## BID PACKAGE #2 ADDENDUM #01

**DATE:** December 5, 2024      **PROJECT NO:** 24-038  
**TO:** Gramoll Construction      **PROJECT:** DTC Welding Technology Bldg  
155 S 750 W St  
North Salt Lake, Utah 84054

The original specifications and drawings, labeled “Bid Package #2”, dated November 1, 2024 and issued for the project referenced above are amended by the following content and form a part of the Contract Documents.

LEVEL 1 FLOOR PLAN  
AE101.2

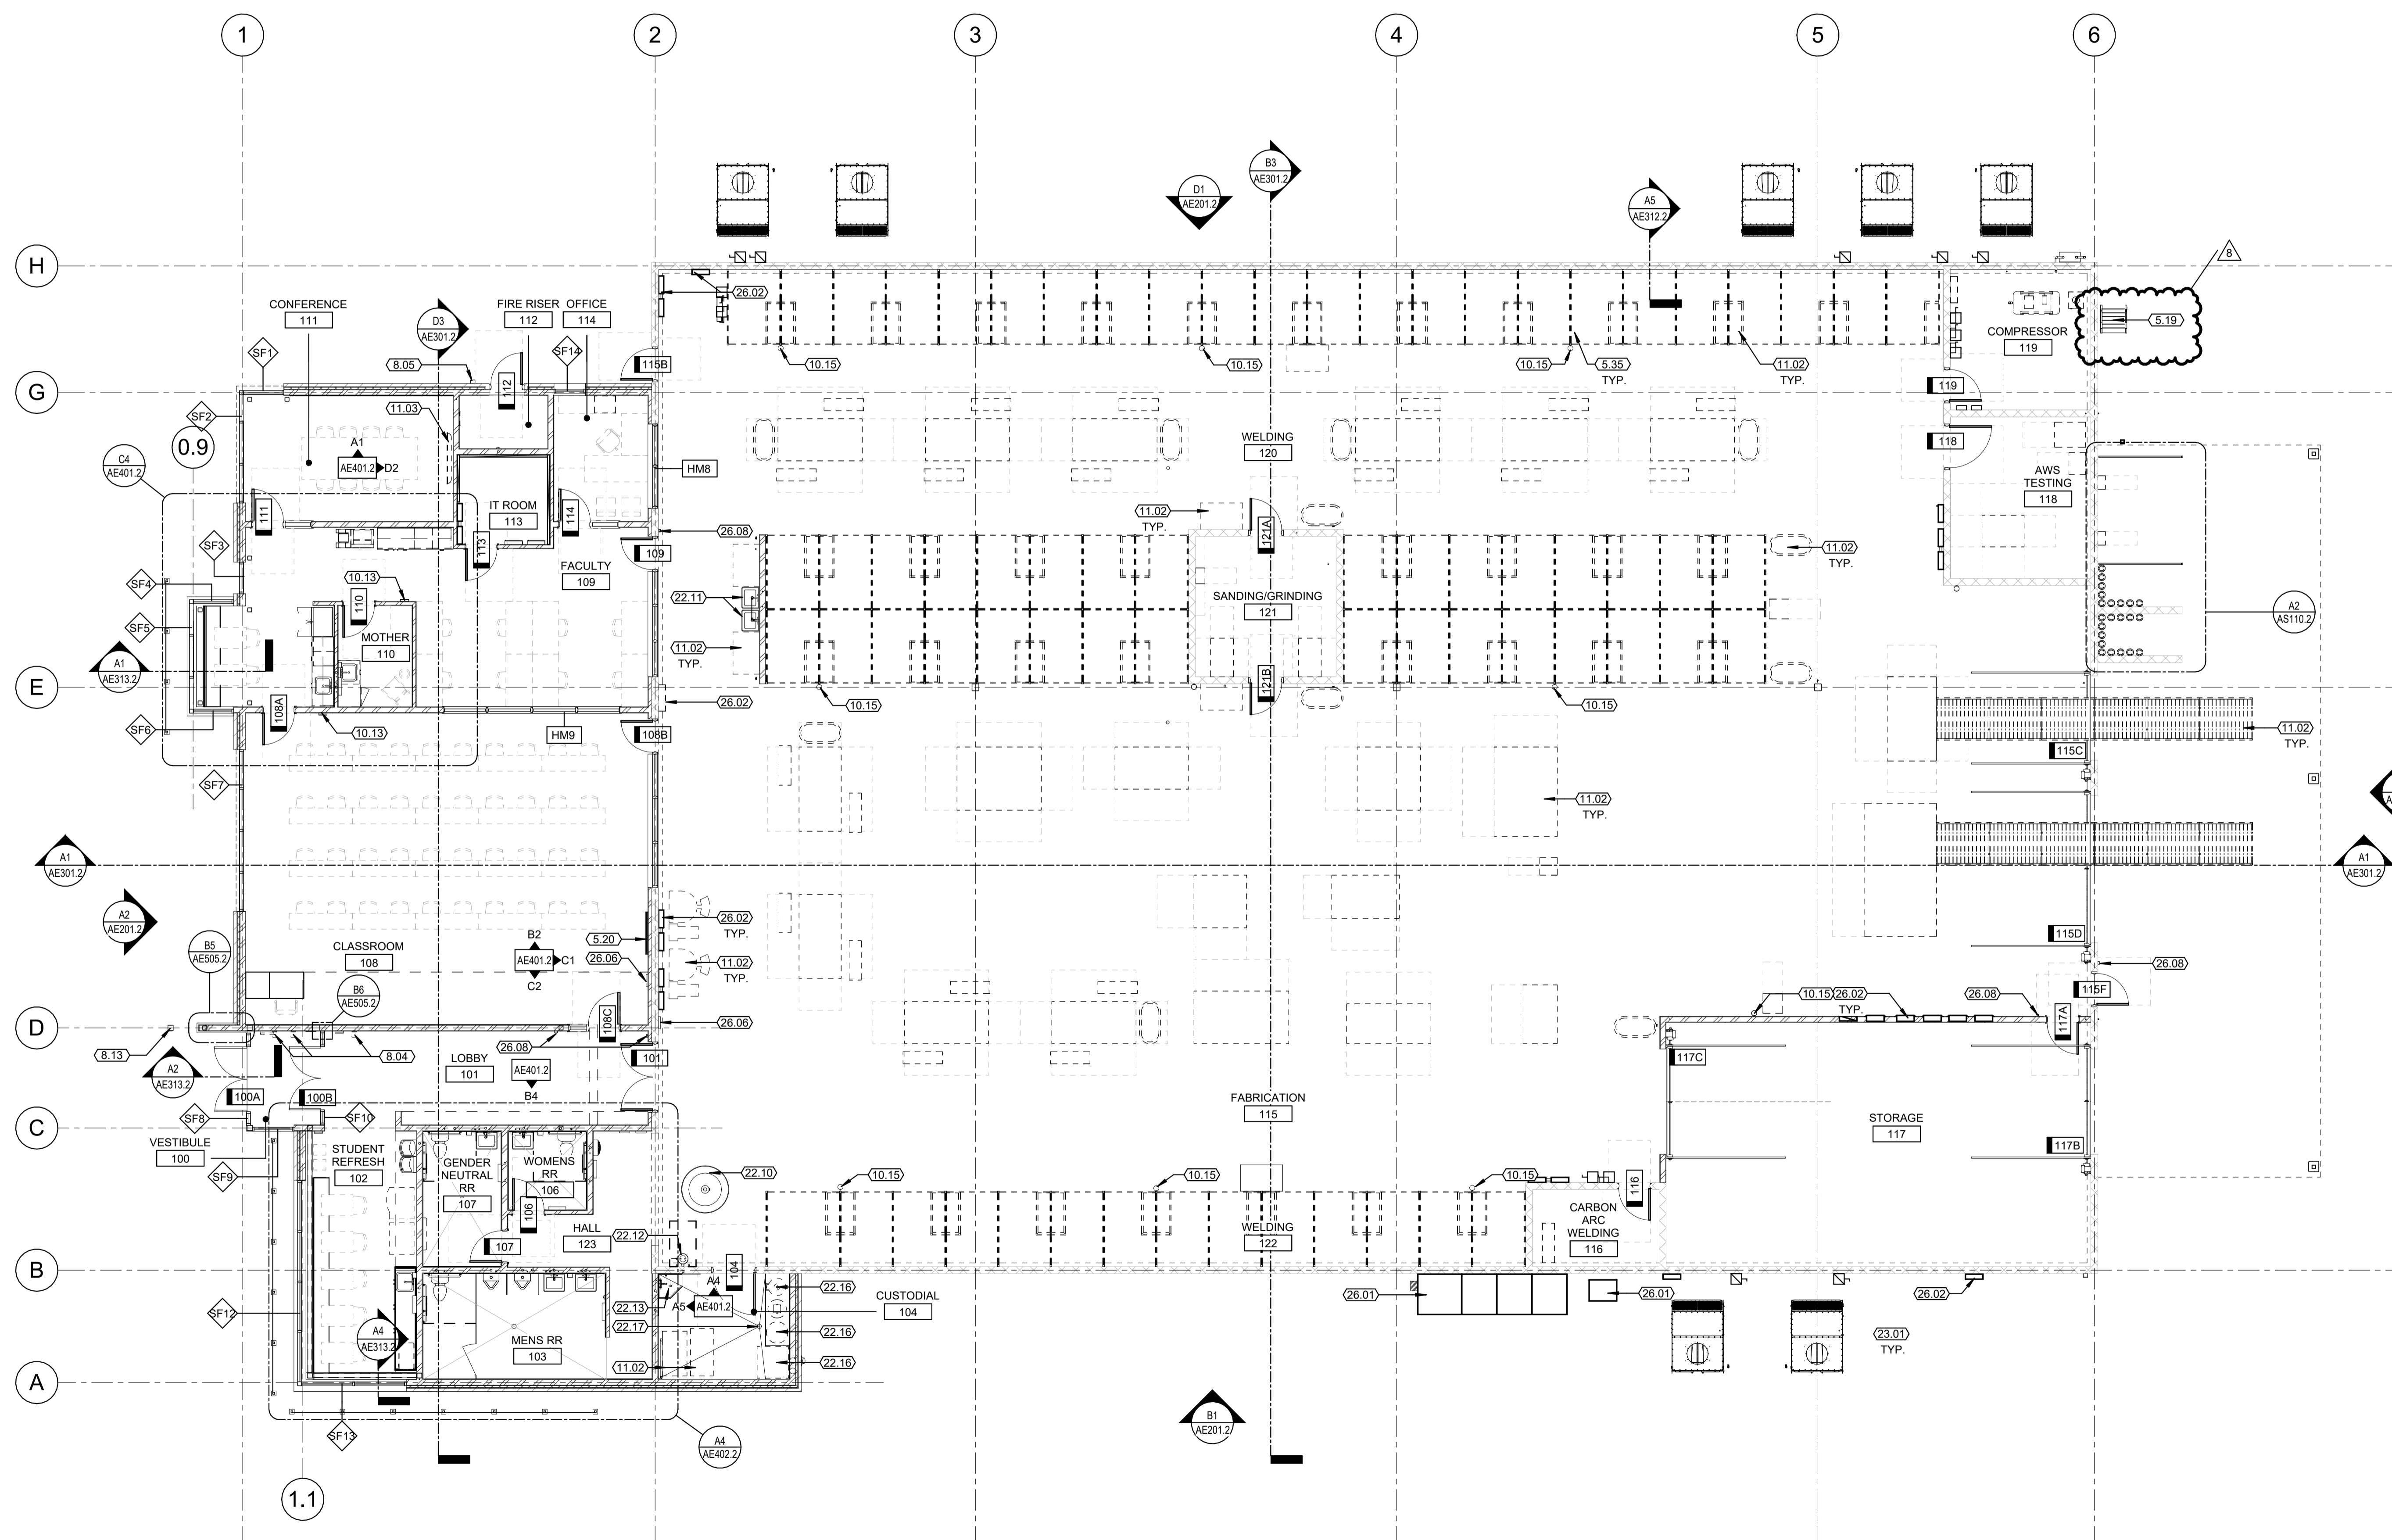
- a. AS101.2
  - i. Revised drawings to show new ships ladder location, chainlink fence & gate.
- b. AS110.2
  - i. Added trench drain across lower end of sidewalk slope at entry plaza.
- c. AE101.2
  - i. Revised ships ladder location.
- d. AE151.2
  - i. Added alternate base material for Base Finish BS1. Bidders to provide alternate pricing for this material.
- e. AE191.2
  - i. Revised ships ladder location & deleted roof hatch.
- f. AE201.2
  - i. Revised exterior elevations to show new ships ladder location & chainlink fence.
- g. AE402.2
  - i. Revised interior elevations to show revised student refresh millwork.
- h. AE525.2
  - i. Revised ships ladder details.
- i. AE530.2
  - i. Revised student refresh millwork elevation to add cabinets. Deleted countertop bracing detail.

LEVEL 1 FLOOR  
FINISH PLAN  
**AE151.2**

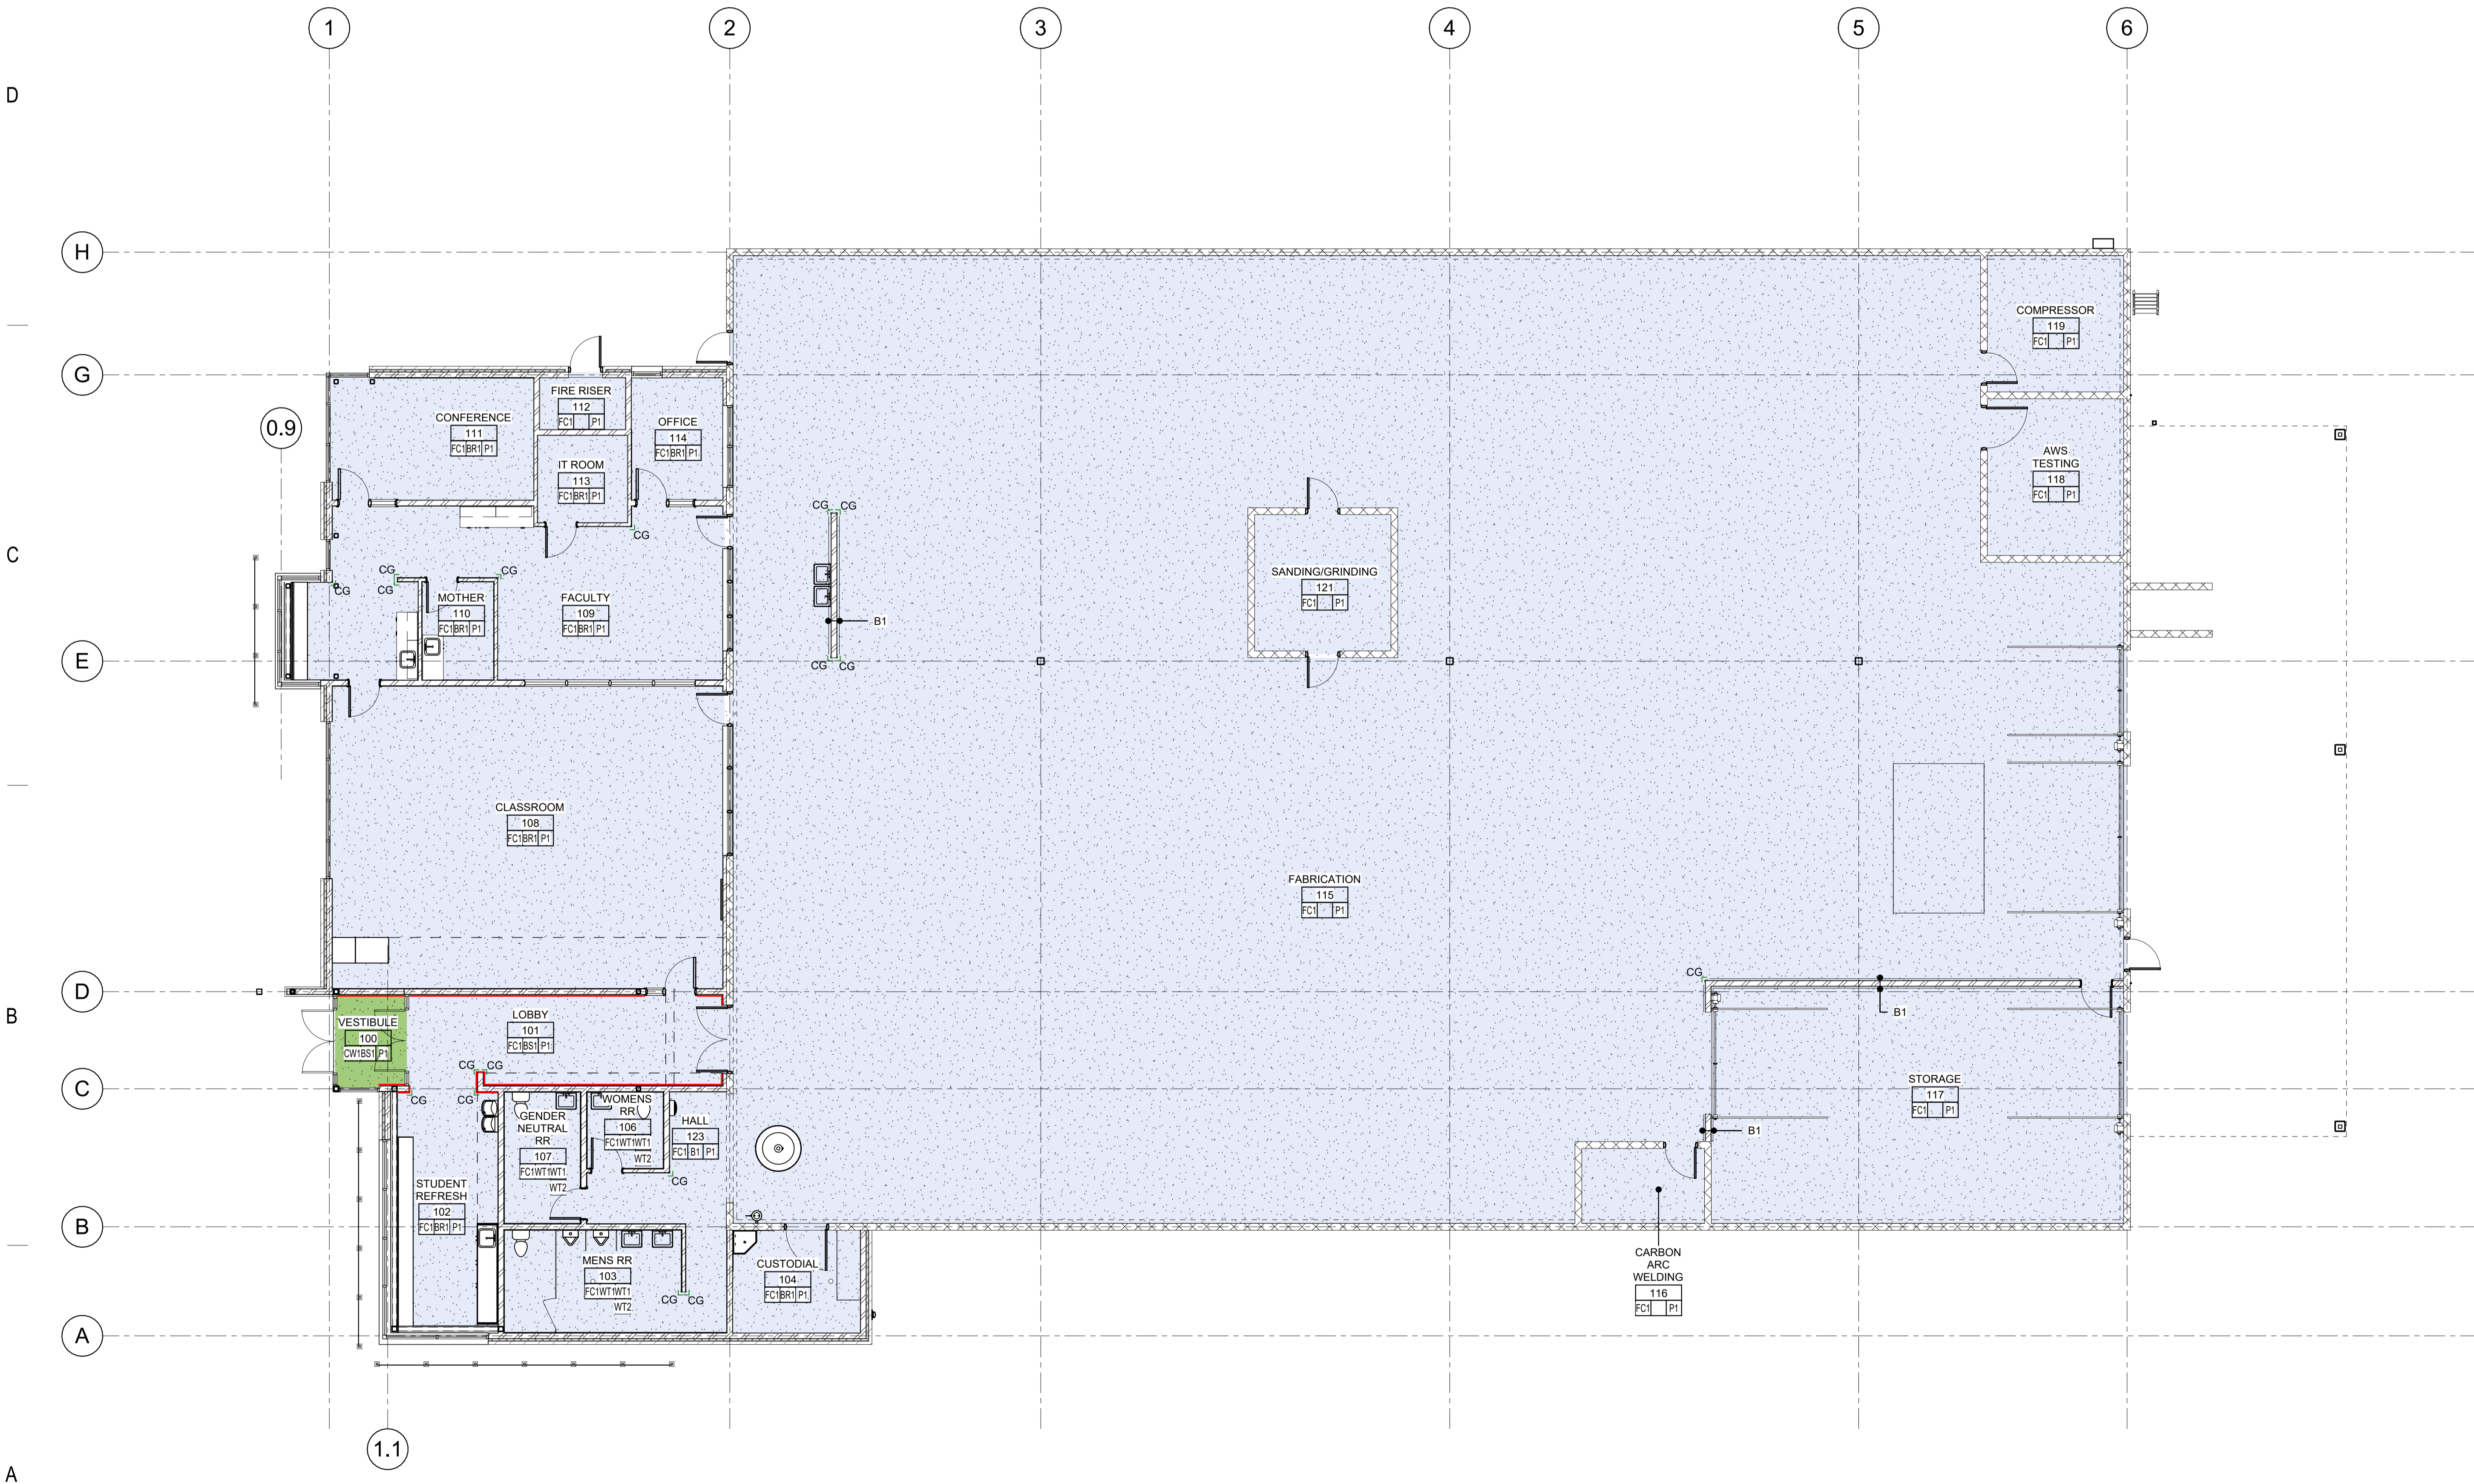
1. Q: Please confirm height of chainlink fence.  
A: *Chainlink fence and gate heights are 72”H. Please see attached drawing revisions.*
2. Q: On the floor finish plans in one place it says densified concrete and in another place it says FC1 is polished concrete. Can you confirm which one is correct?  
A: *Densified concrete is correct. Please see attached drawing revisions.*
3. Q: Roofing substitution request.  
A: *Approved as noted. See attached form.*
4. Q: MCM Panel substitution request.  
A: *Approved as noted. See attached form.*
